Addendum #1

PROJECT: Department of VA Sioux Falls, South Dakota ED Oncology Renovation and Expansion Sioux Falls, South Dakota	ADDENDUM NO.	001
	DATE ISSUED:	January 15, 2016
	BIDS DUE:	January 27, 2016

VA PROJECT NUMBER: 263-P-1038
TSP PROJECT NUMBER: 04121122

ROOF (FUTURE FLOOR) ASSEMBLY:

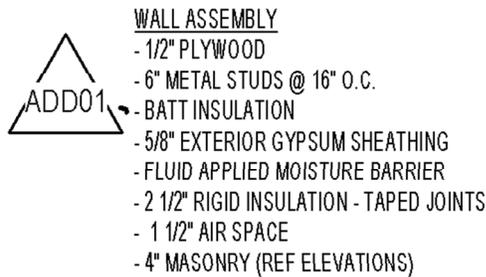
- A. Under "FLOOR AND ROOFING ASSEMBLIES," revise the 'R2' assembly description as noted below:

- ADHERED ROOFING MEMBRANE
- TAPERED RIGID ISO ROOF INSULATION
- 2" BASE LAYER RIGID ISO ROOF INSULATION
- REINFORCED CONCRETE SLAB (REF STRUCT)
- COMPOSITE METAL FLOOR DECK (REF STRUCT)
- STEEL BEAM OR JOIST (REF STRUCT)

SB1 EXTERIOR WALL
STEEL STUD WITH MASONRY

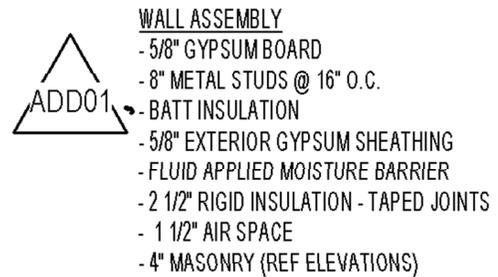
- C. Under “EXTERIOR WALL TYPES,” add “BATT INSULATION” to the “WALL ASSEMBLY” descriptions of types ‘SB1’ and ‘SB2’. Reference below.
